City of San Diego
Planning Department

Environmental Impact Report

EQD No. 84-0160
SCH No. 84030708

SUBJECT: Sea World Master Plan. COUNCIL ADOPTION of a Master Land Use Plan as a condition of a 32-acre, 50-year ground and water lease negotiated by Sea World and the City Manager. Key features include expansion of the theme park, marina and parking areas. Located between Sea World Drive and Mission Bay just east of Ingraham Street in the South Shores area of Mission Bay Park. Applicant: Sea World, Inc.

LANDSCAPE PLAN
INTERNAL PARKING LOT SCREEN TYPICAL AT PERMANENT PARKING

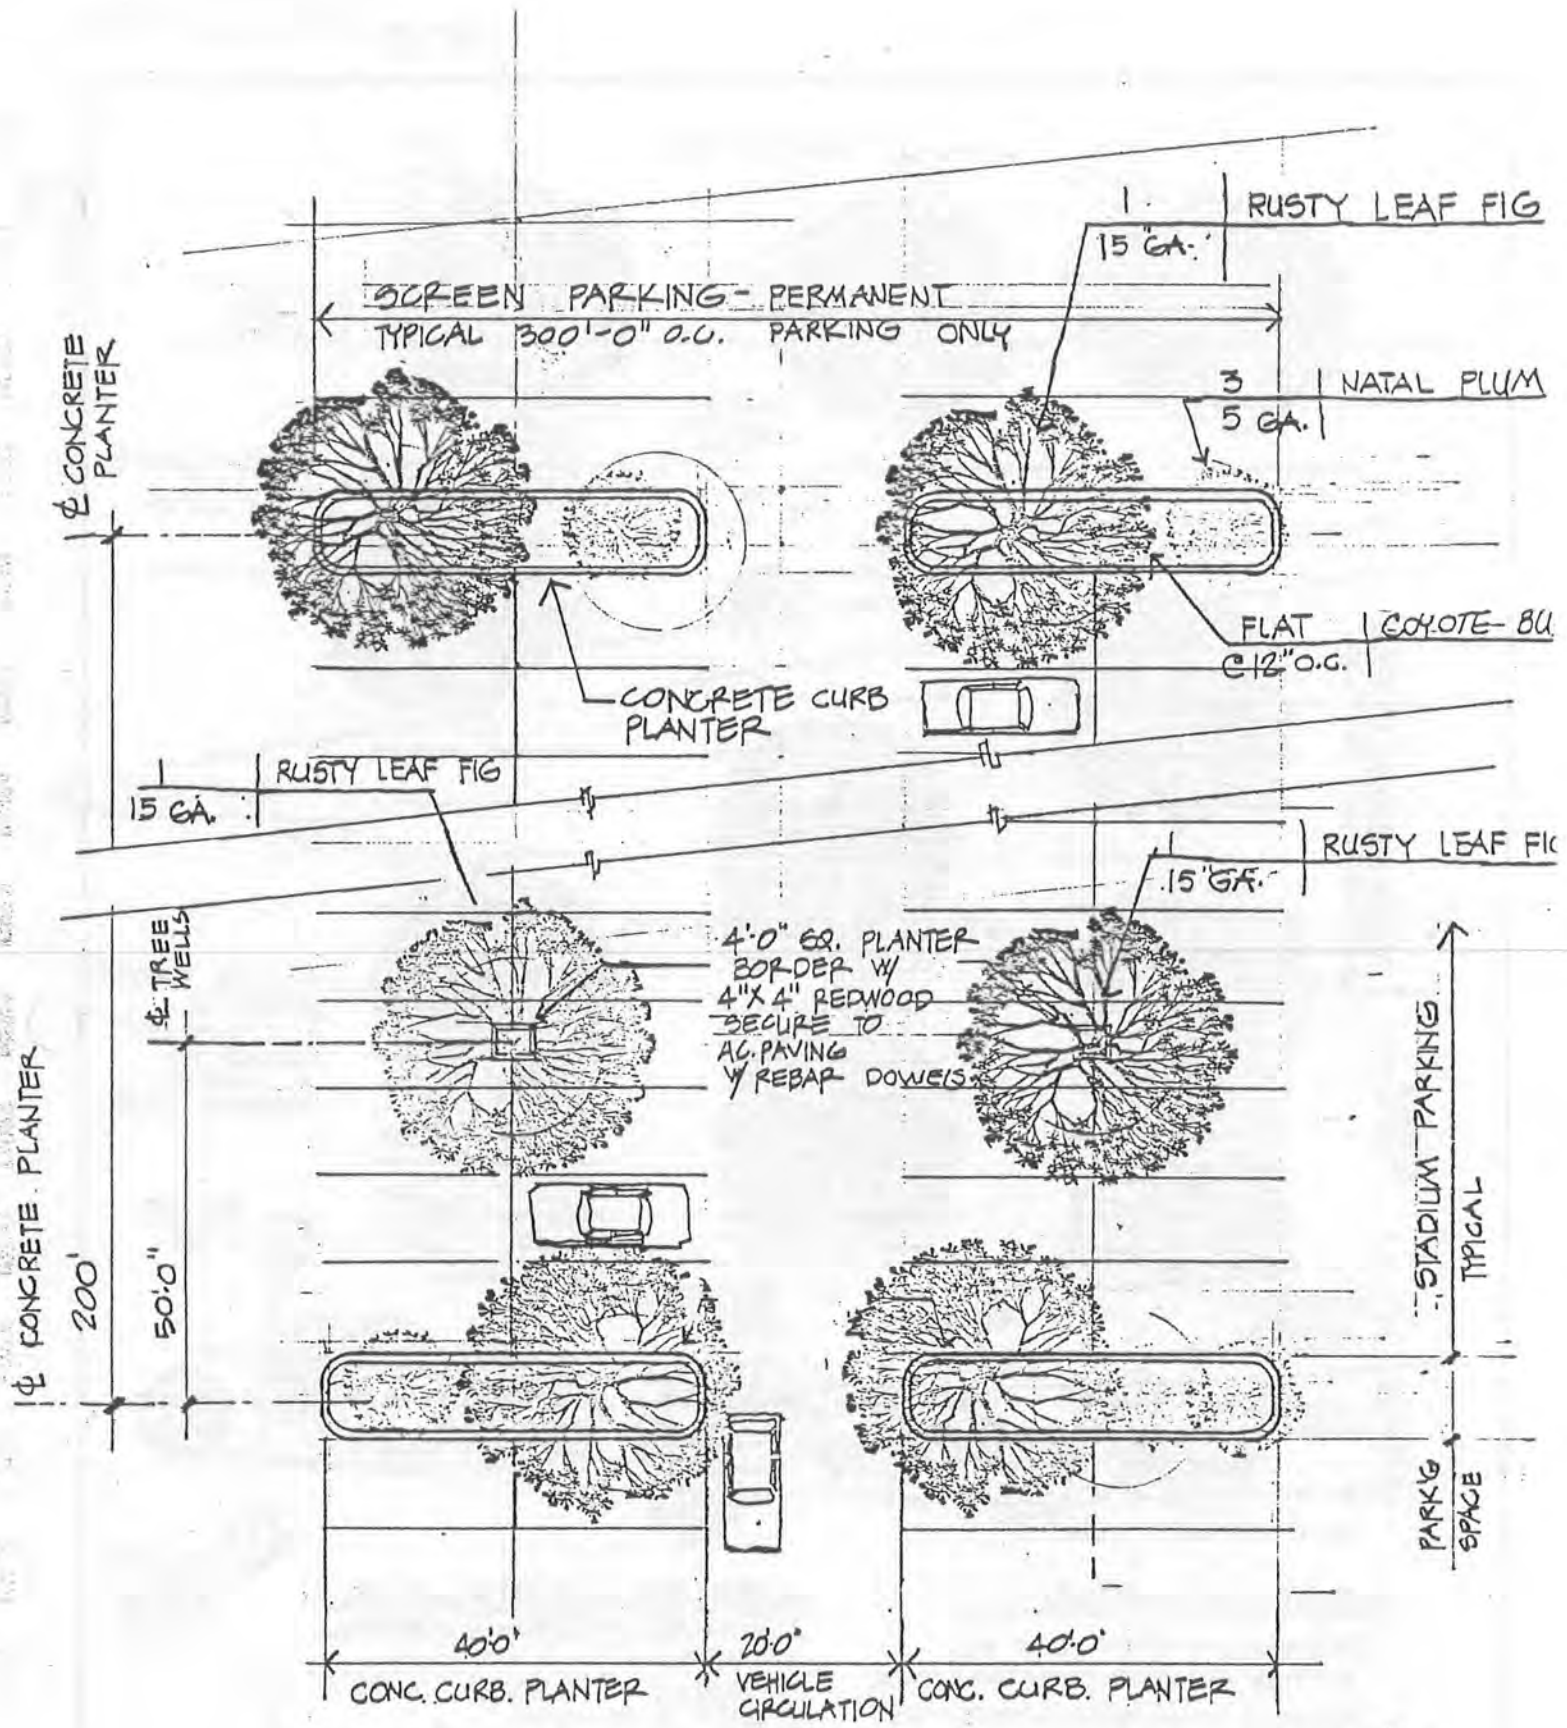
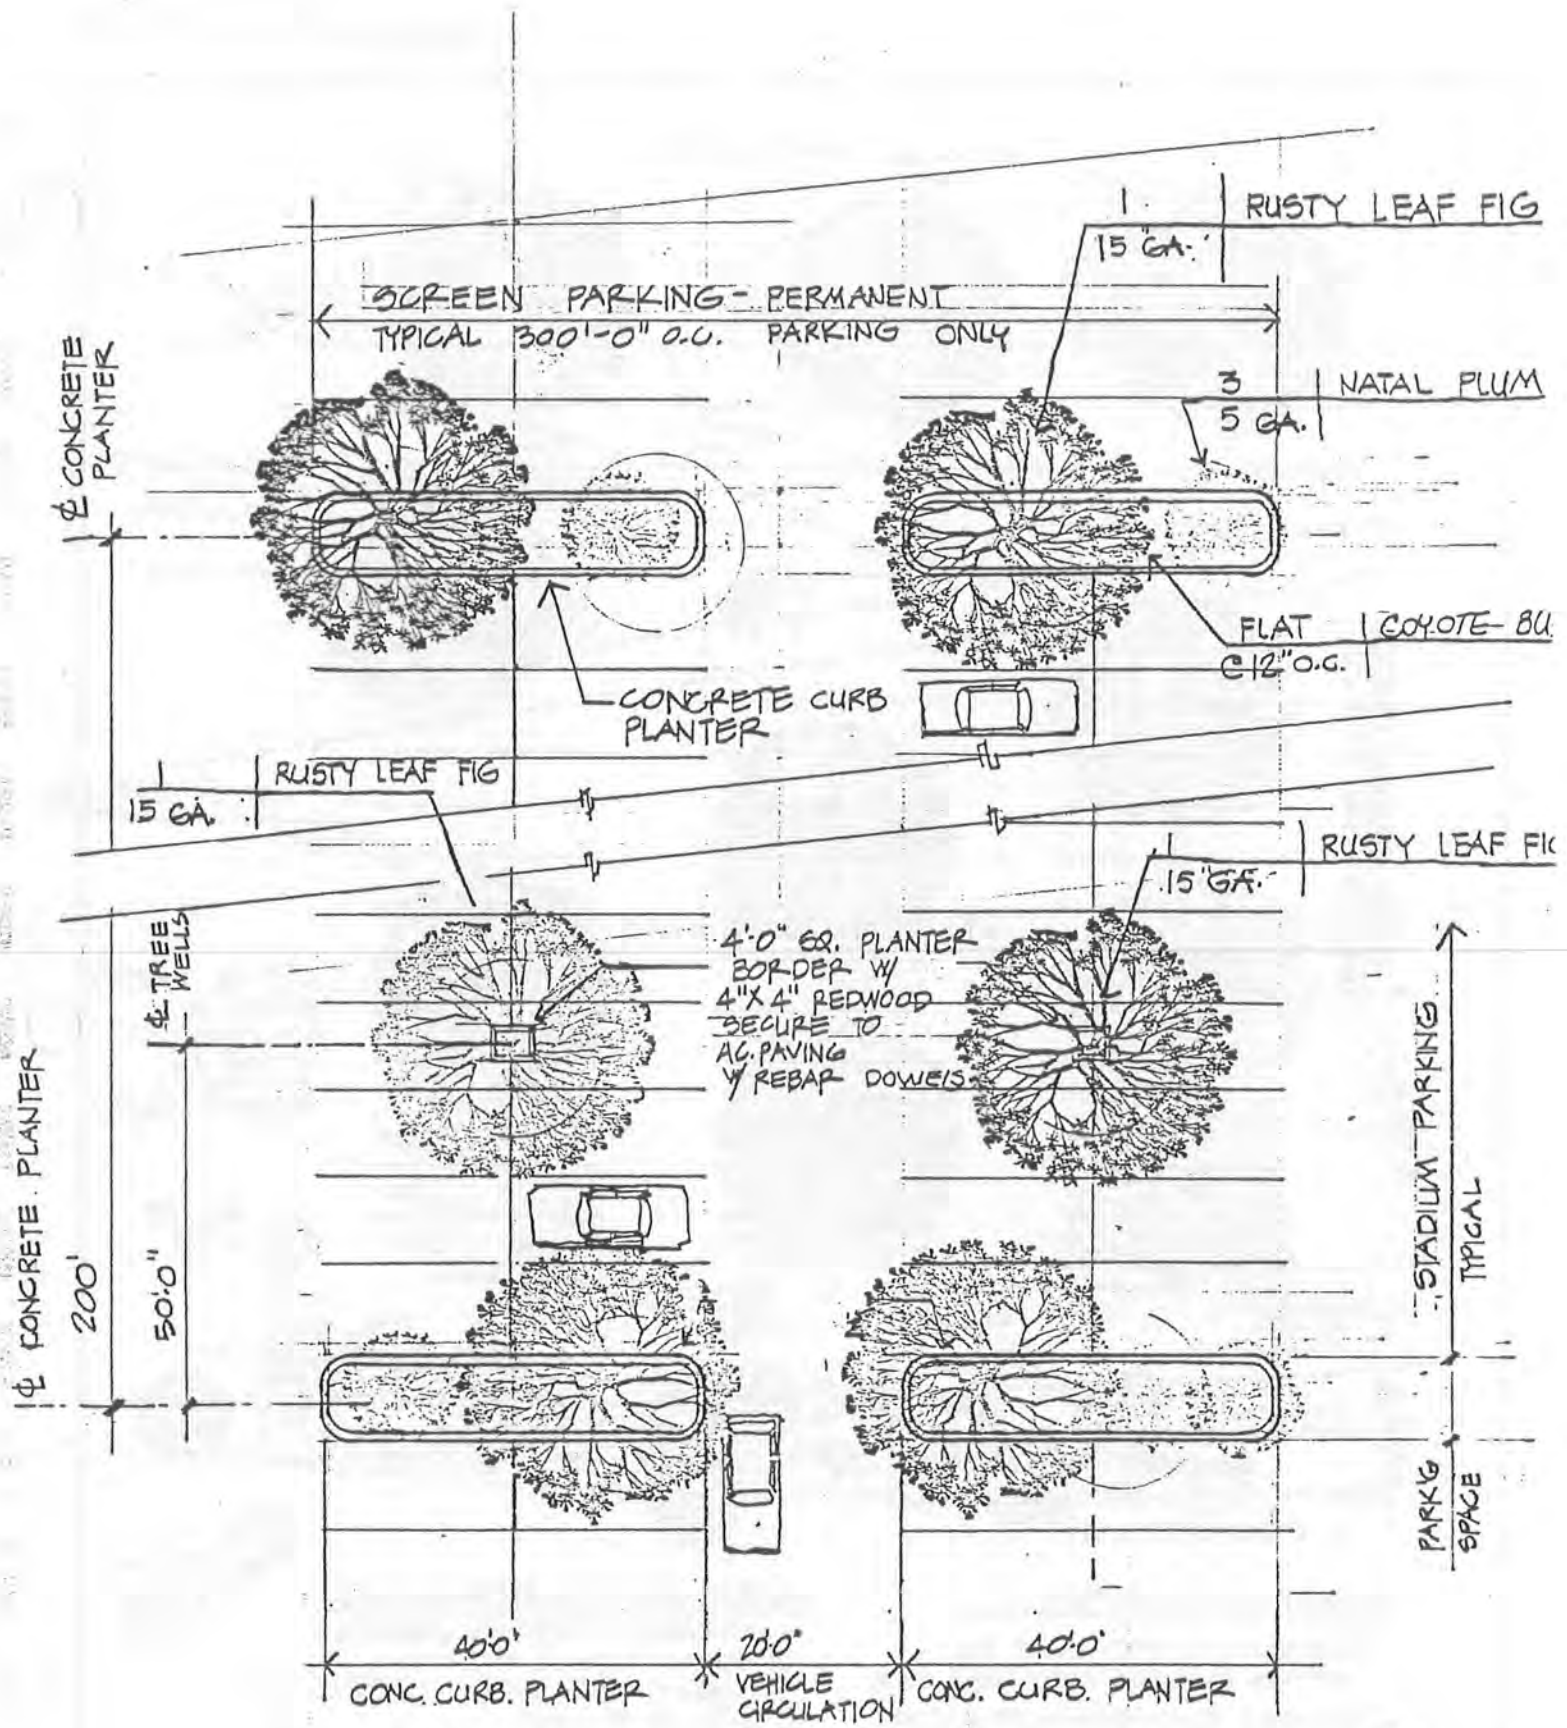
Several outstanding issues remain regarding the landscaping design. The plans show Coyote Bush planted as ground cover, except on the bermed planter (see Landscape Plan - Internal Parking Lot Screen) where English Ivy is shown. A ground cover other than English Ivy is recommended in order to conserve water and provide greater compatibility with the New Zealand Christmas Tree. Perimeter trees, designed to provide a visual screen between Sea World and adjacent properties, should be planted as specimen-size trees (e.g., 24-inch or 36-inch box) rather than the 15 gallon size shown on Figure 4-10. Additionally, the plans should specify the species that would be used for landscape screen planting (Figures 4-9 and 4-10), since eucalyptus and acacia are common names referring to literally hundreds of varieties.
